AGENDA

CITY OF NORMAN, OK
HISTORIC DISTRICT COMMISSION MEETING
Municipal Building, Council Chambers, 201 West Gray, Norman, OK 73069
Monday, March 02, 2026 at 5:30 PM

ITEM TITLE: (HD 26-06) CONSIDERATION OF APPROVAL, REJECTION, AMENDMENT, AND/OR POSTPONEMENT OF AMENDMENTS TO CERTIFICATES OF APPROPRIATENESS 24-08 AND 25-04 FOR THE PROPERTY LOCATED AT 1320 OKLAHOMA AVENUE FOR THE FOLLOWING: A) MODIFICATIONS TO THE CONCRETE PATIO AND COVERED PERGOLA; B) MODIFICATIONS TO THE FRONT WALKWAY AND YARD; C) EXTENSION OF THE RETAINING WALL; D) CHANGE IN THE EXTERIOR WALL MATERIALS; E) THE ADDITION OF TWO EXTERIOR DOORS ON THE SOUTH SIDE OF THE STRUCTURE; F) MODIFICATIONS TO THE GARAGE DOOR DESIGN; G) MODIFICATIONS TO THE WINDOWS.

The applicant was approved for a new house, accessory dwelling unit, and a covered pergola at the March 8, 2025, Historic District Commission meeting. The applicant is now returning to the Commission to request modifications to the approved design for the property with the following amendments:

# 1- Modifications to the proposed patio and covered pergola

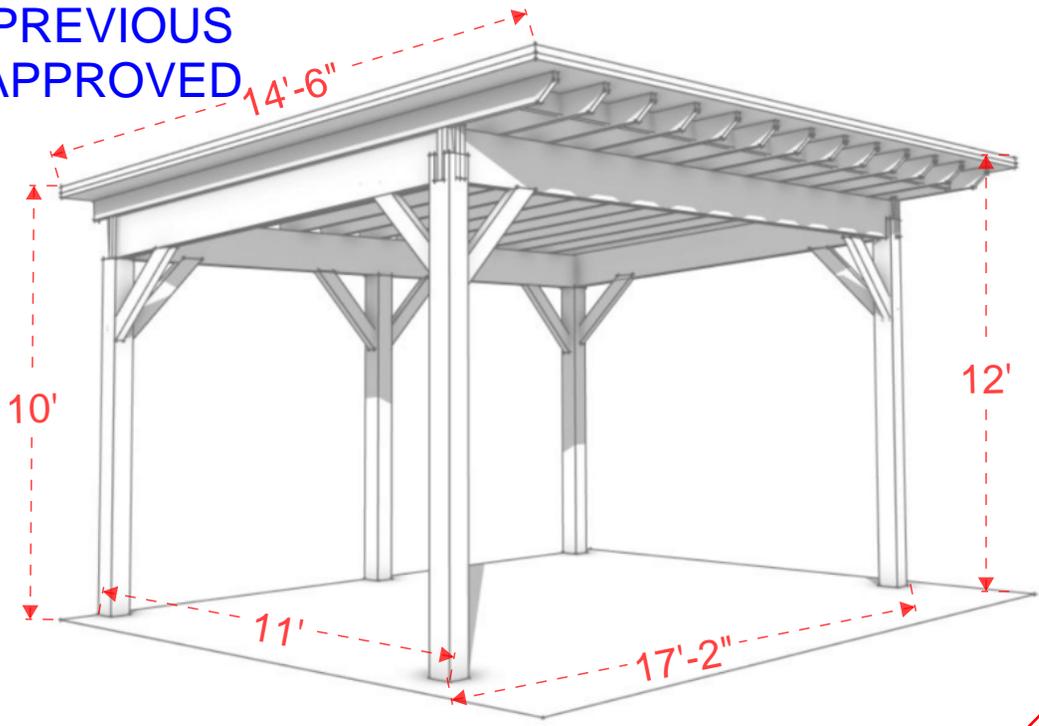
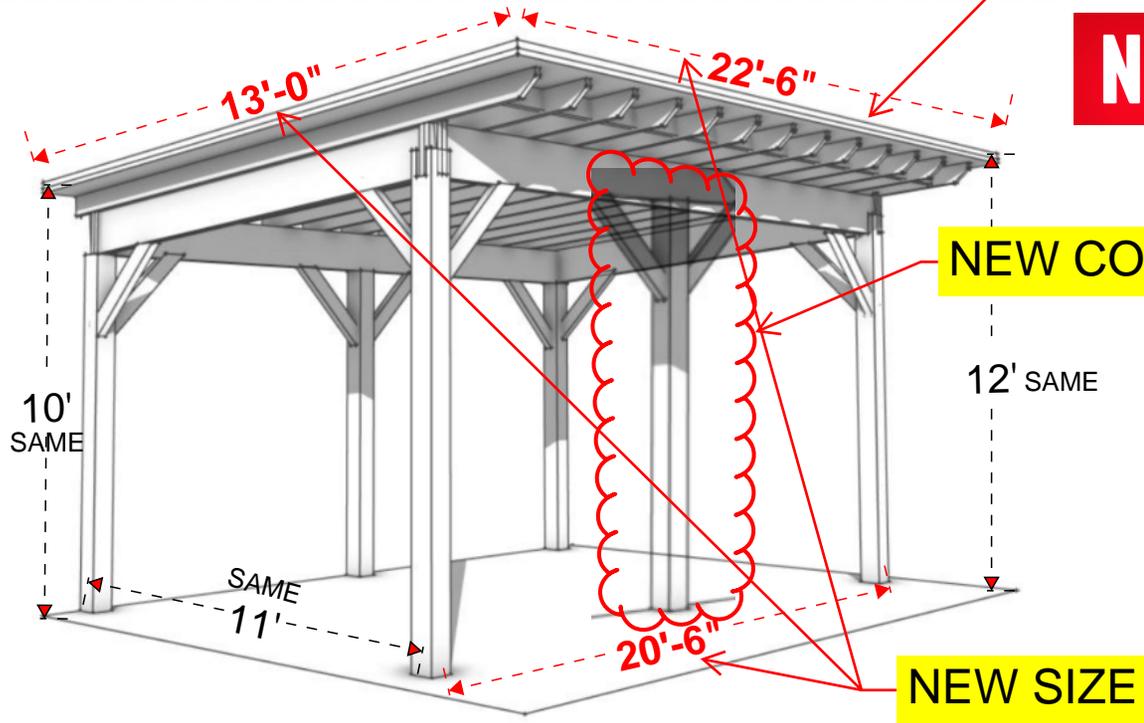
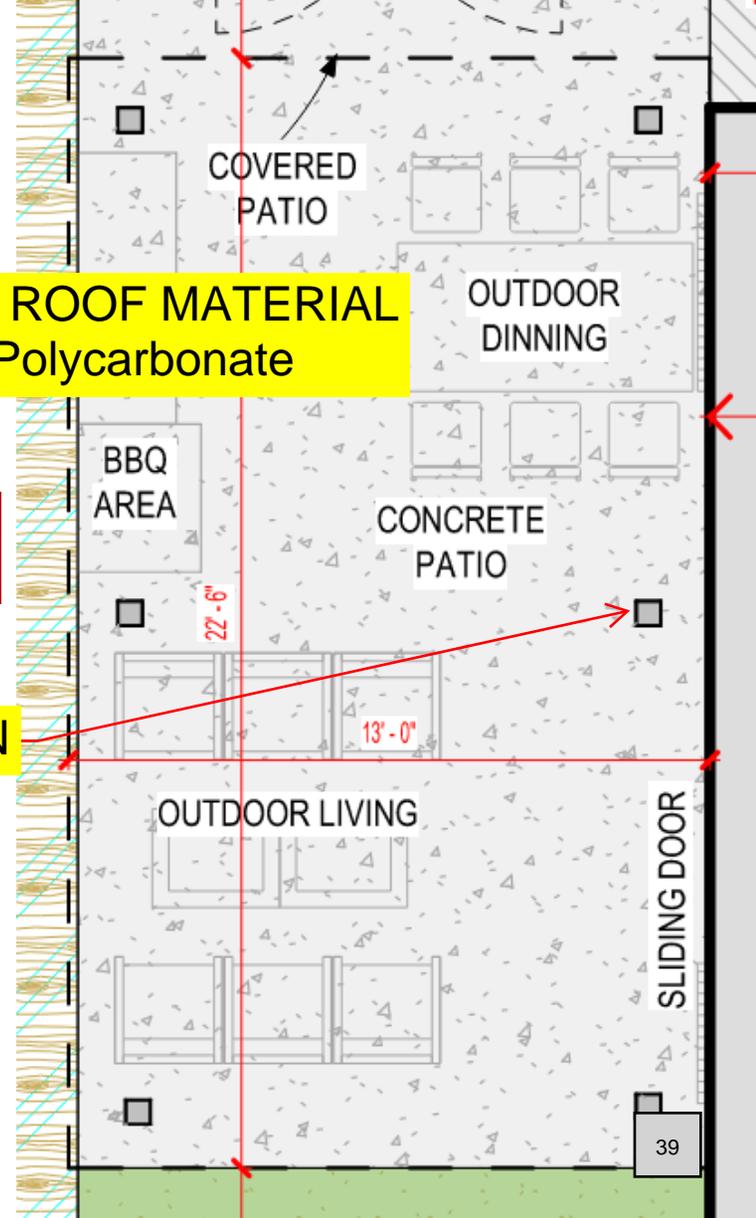
The applicant proposes to increase the size of the concrete pad and pergola sizes, add a support column to the pergola, and change the pergola roof material. The width of the concrete patio is proposed to increase from 19' x 15' with a total of 285 square feet to 26'6" by 13' for a total of 344.5 square feet. The detached wood pergola is proposed to increase from 11' by 17.2' and approximately 246 square feet to 11' by 20.5' and approximately 266.5 square feet. An additional support column is proposed for the pergola. The originally asphalt shingle roof is now proposed to be replaced with a high-impact polycarbonate material. The pergola's roof will slope towards the rear yard, to allow water to drain away from the house. The covered pergola meets the required setbacks of the Zoning Ordinance. This increase in size still meets the maximum impervious surface coverage requirements.

No ADU allows more room for pergola

NEW ROOF MATERIAL  
Polycarbonate

NEW COLUMN

NEW SIZE

Item 2.

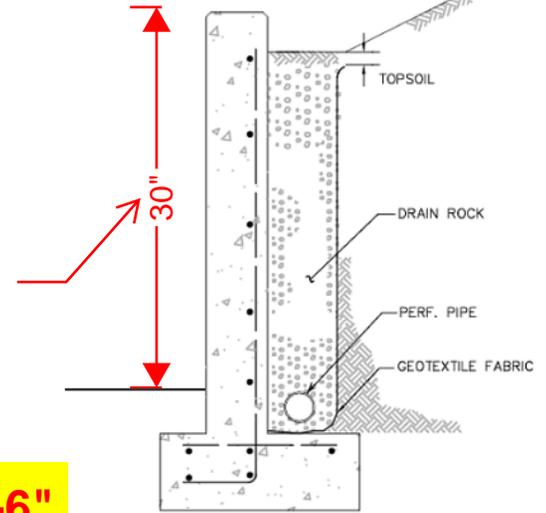
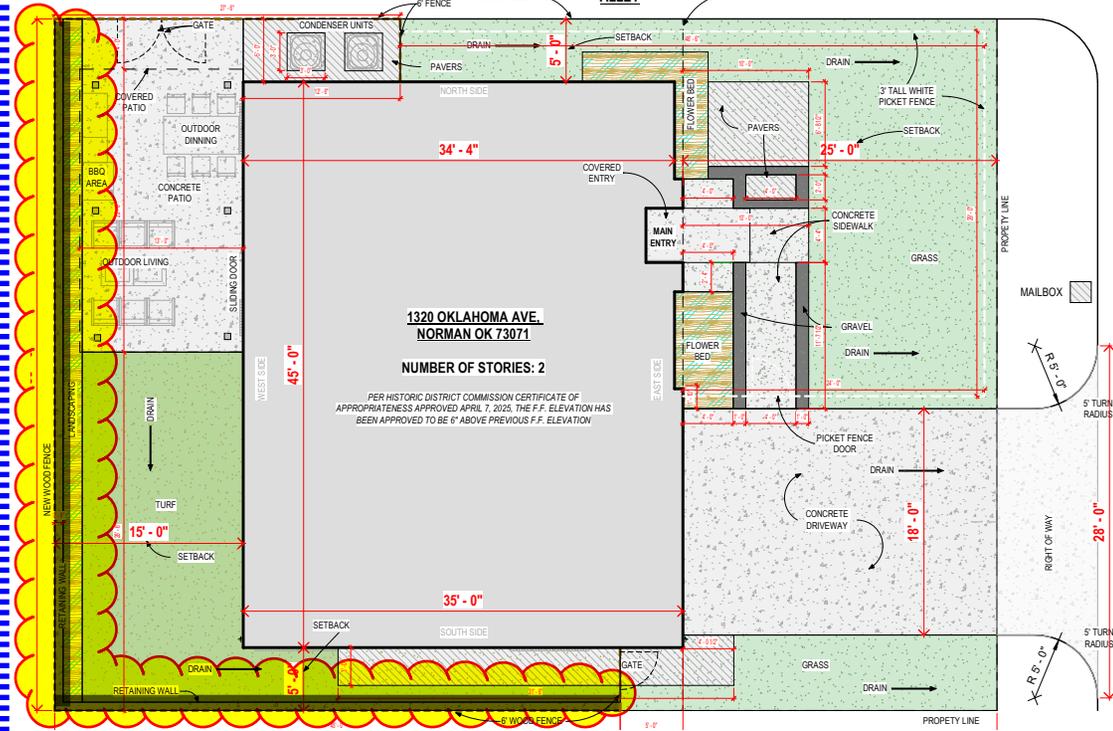
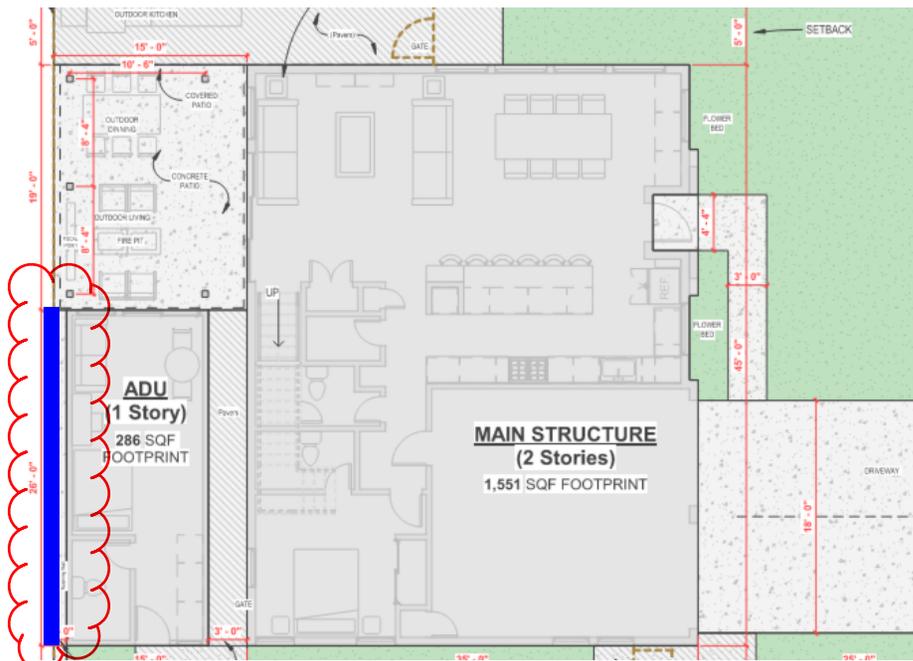
To mitigate water overflow flow the request is to **extend the length** of the retaining wall from **36 feet** to **105 feet**.

Average height over low ground 30"

Prior approval = 36ft

New Requested L: 99'-6"

# 5- Request two additional exterior doors

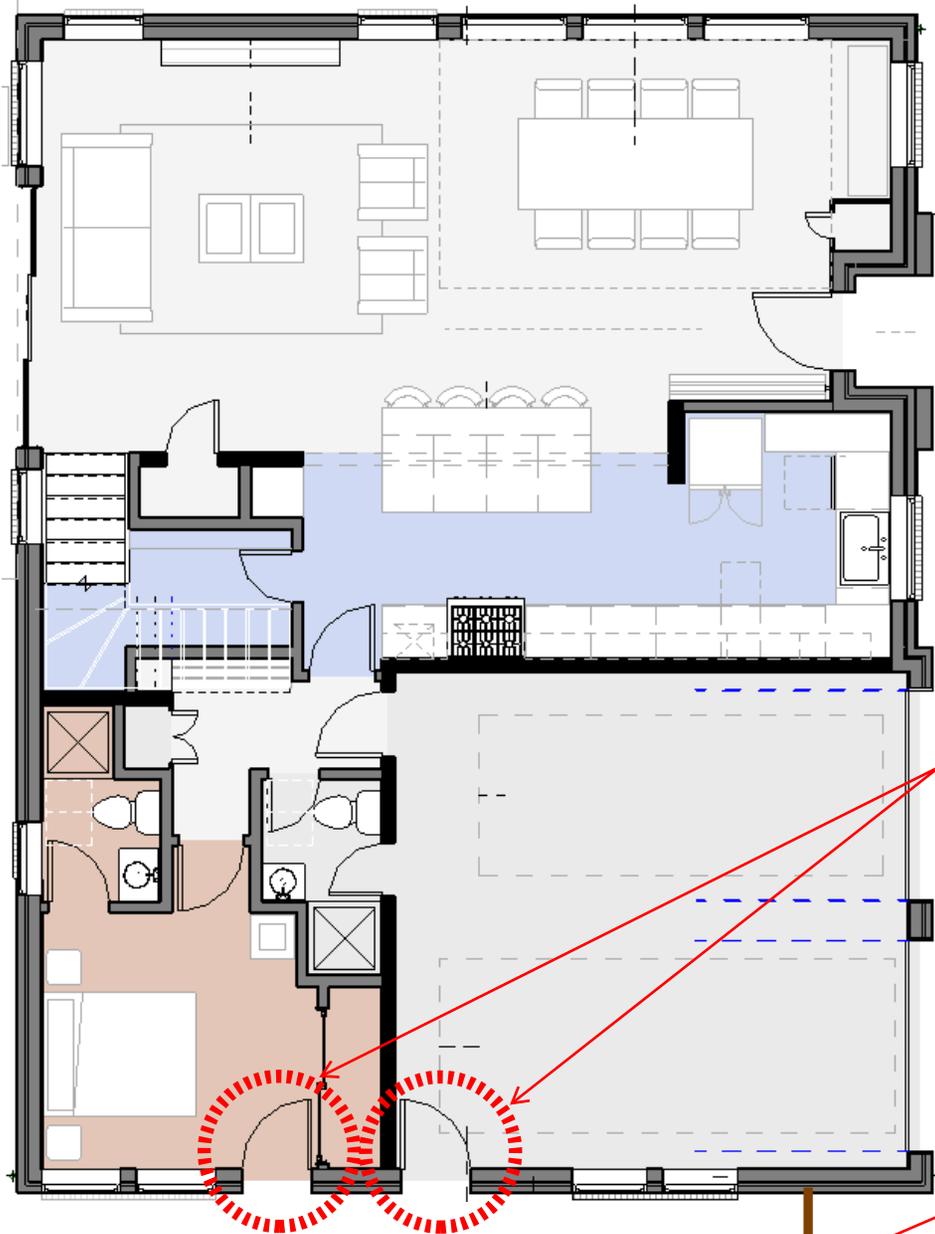
TWO  
NEW  
DOORS

# 6-Change proposed garage door design

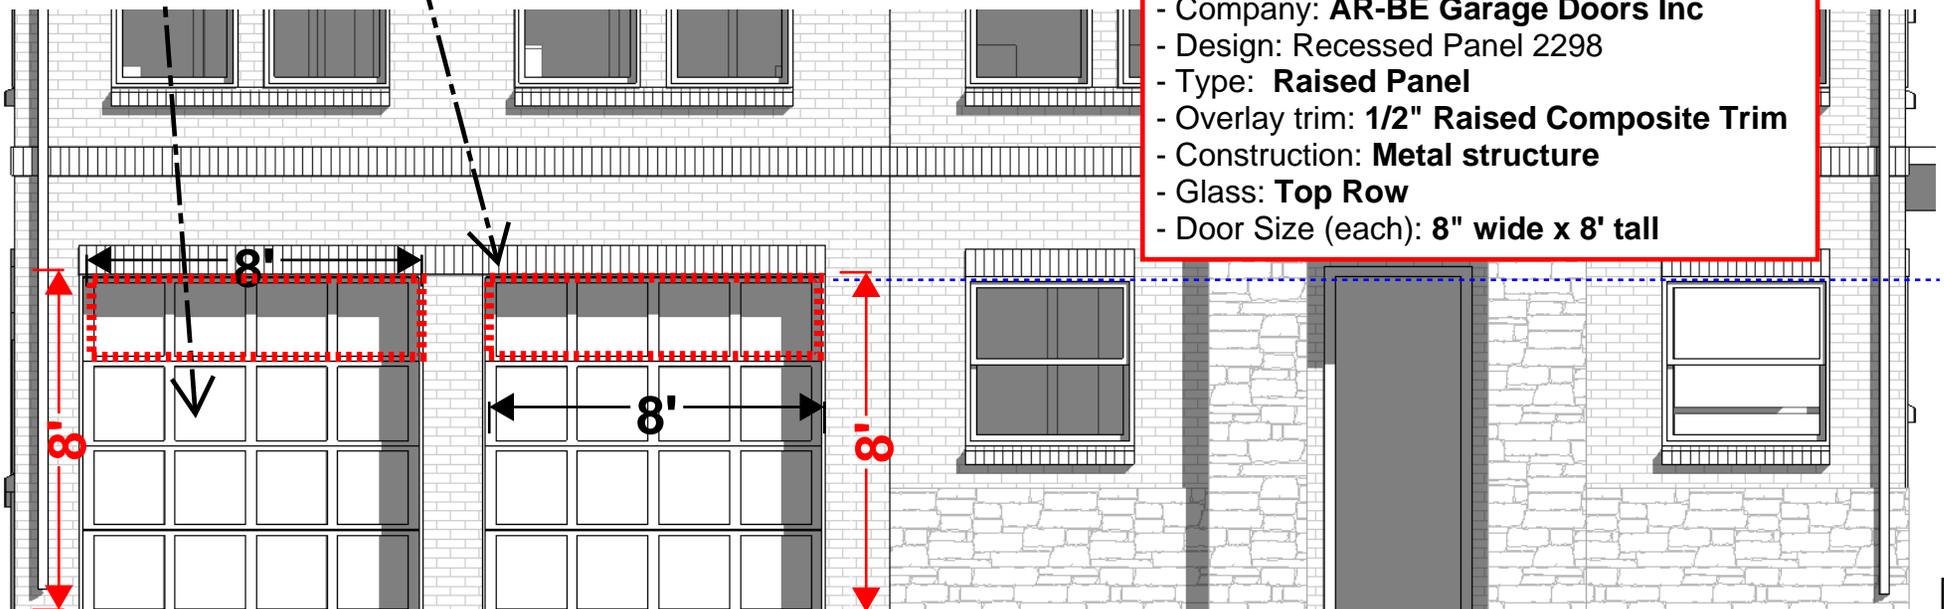
The height of the garage door and the addition of a top row of window lites are typical of a modern-day garage. The proposed modifications to the garage door are minimal and maintain the original design intent previously approved.

USING THE DOOR PREVIOUSLY APPROVED AS A BASIS OF DESIGN WITH **TWO UPGRADES:**

1- GLASS ON TOP ROW

2- INCREASE HEIGHT FROM 7' TO 8' TO MATCH WINDOW HEAD

**+ ADDED 3 WINDOWS  
+RE-ORGANIZE OPENINGS  
+SELECTIVE SIZE CHANGES**

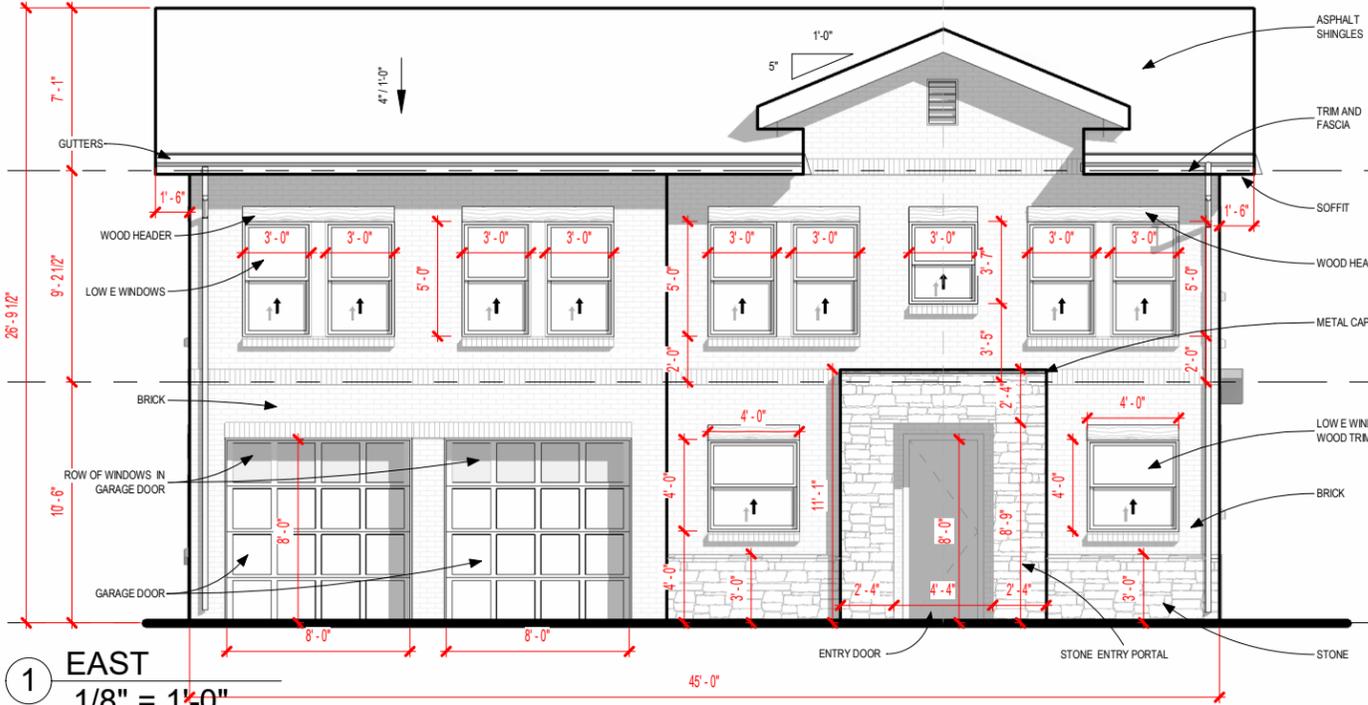
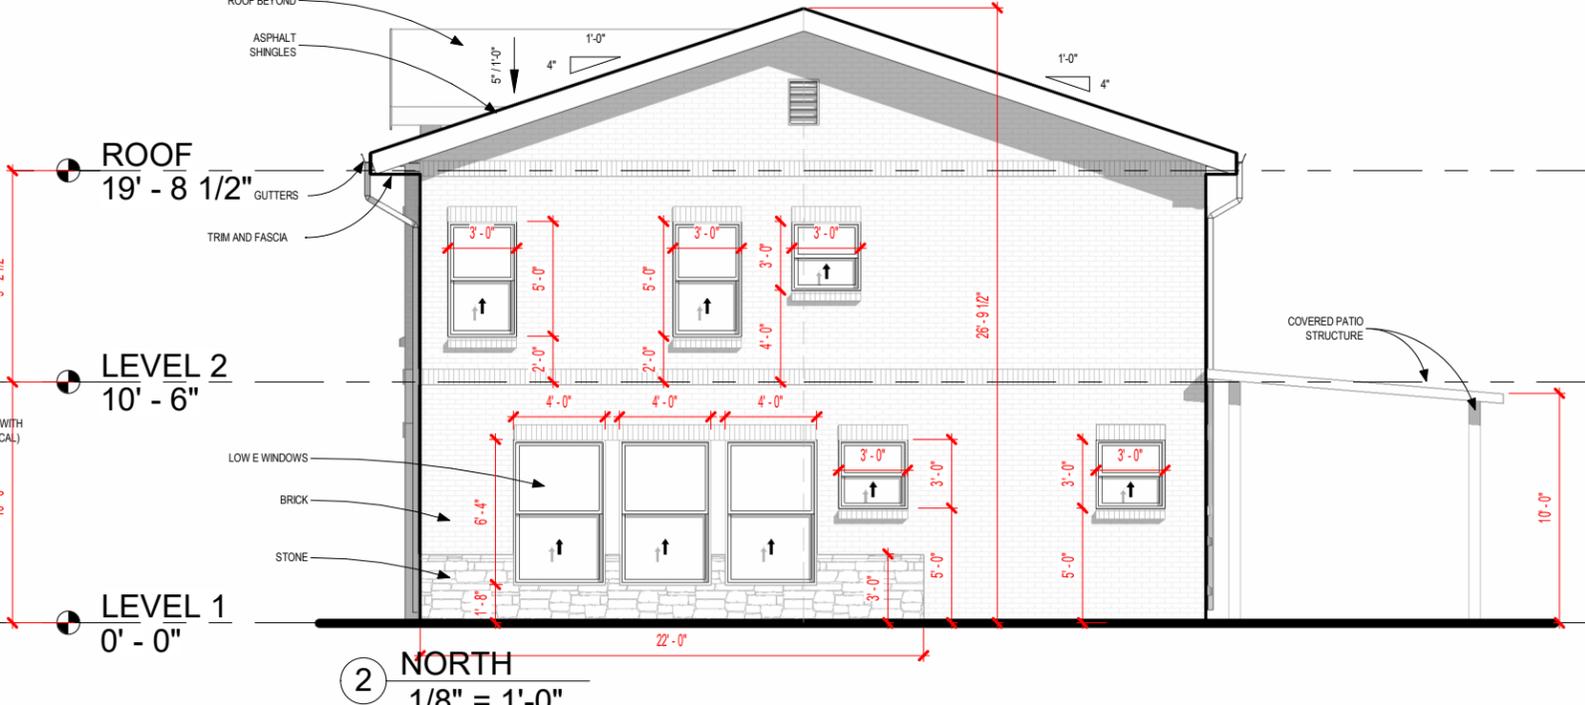
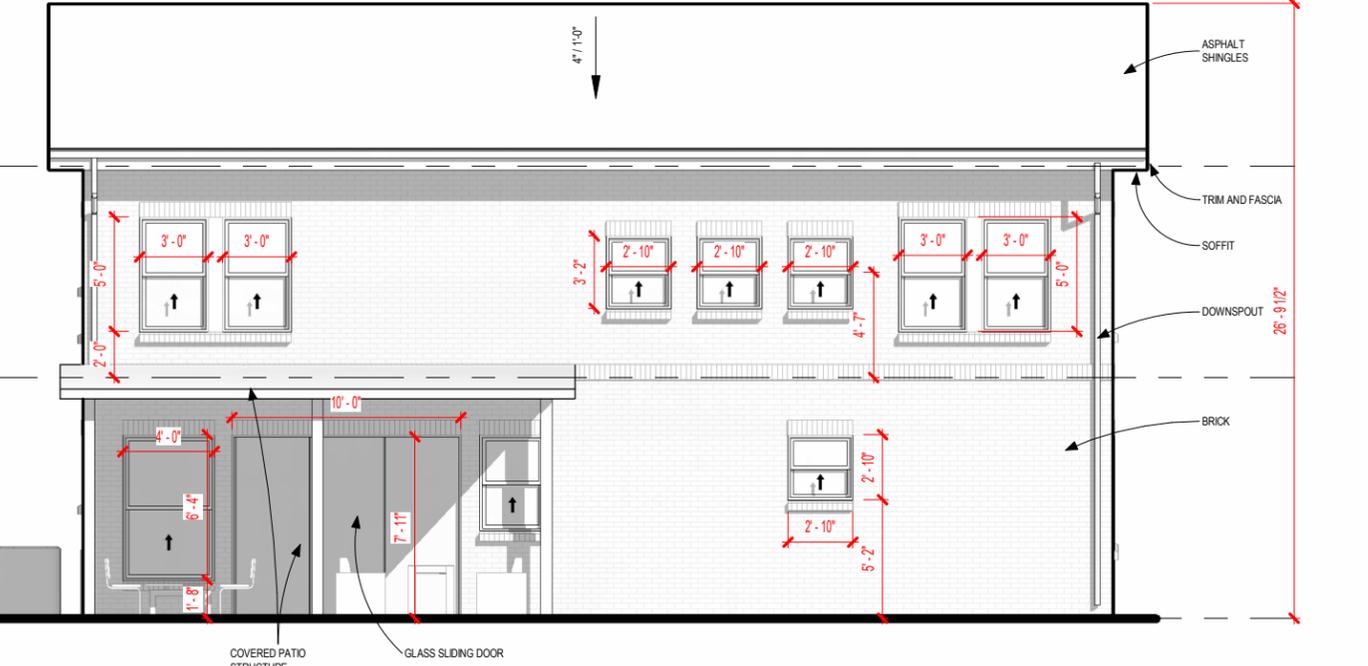
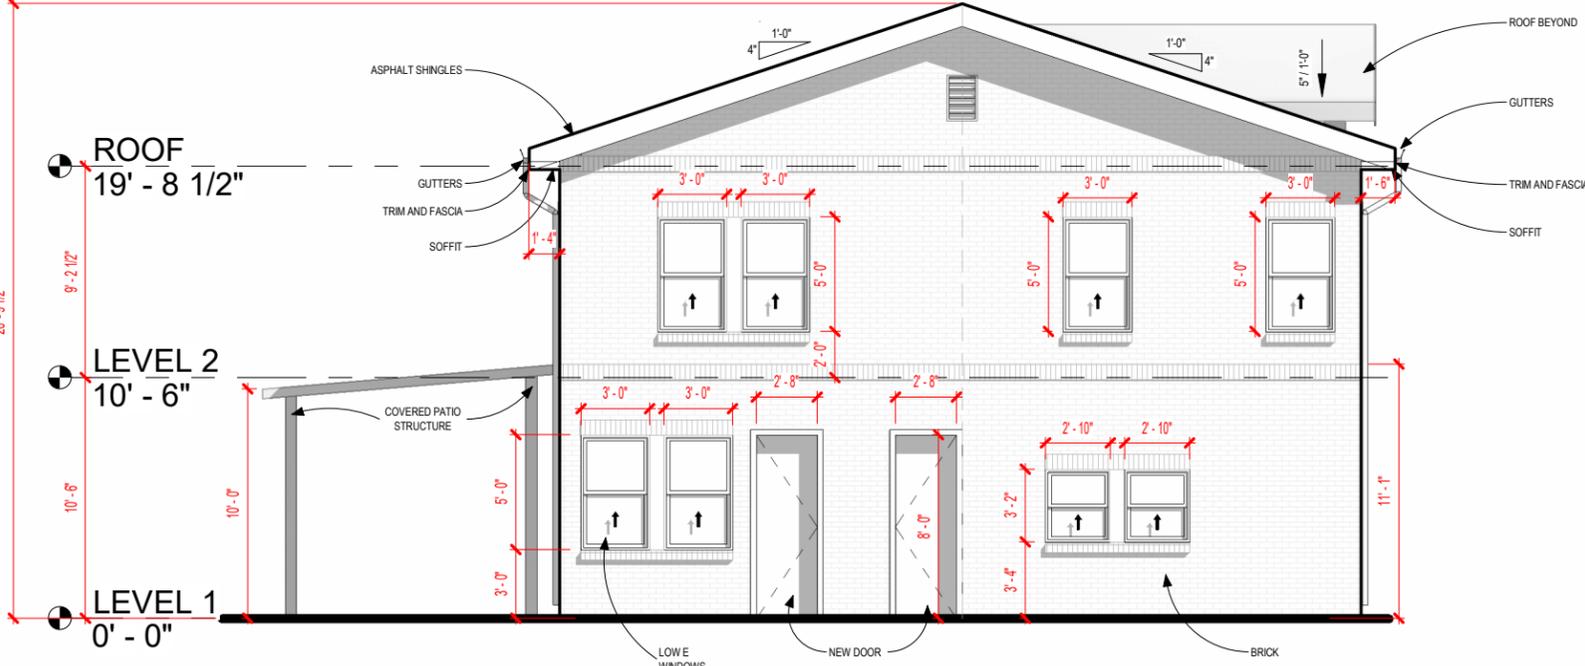
The applicant is requesting to amend the previously approved COA to allow adjustments to the quantity, placement, and size of the windows to accommodate changes to the internal programming of the house. The same aluminum windows previously approved by COA will be utilized. The revised sizes and placements are shown on the submitted drawings.

The applicant proposes the same aluminum windows approved by a previous COA. The applicant is requesting minor modifications to the placement and opening sizes of the previously approved windows on this proposed structure. The requested windows are in harmony with the previously approved windows in terms of size and placement. The requested changes do not appear to significantly alter the exterior design proposed for this new structure.
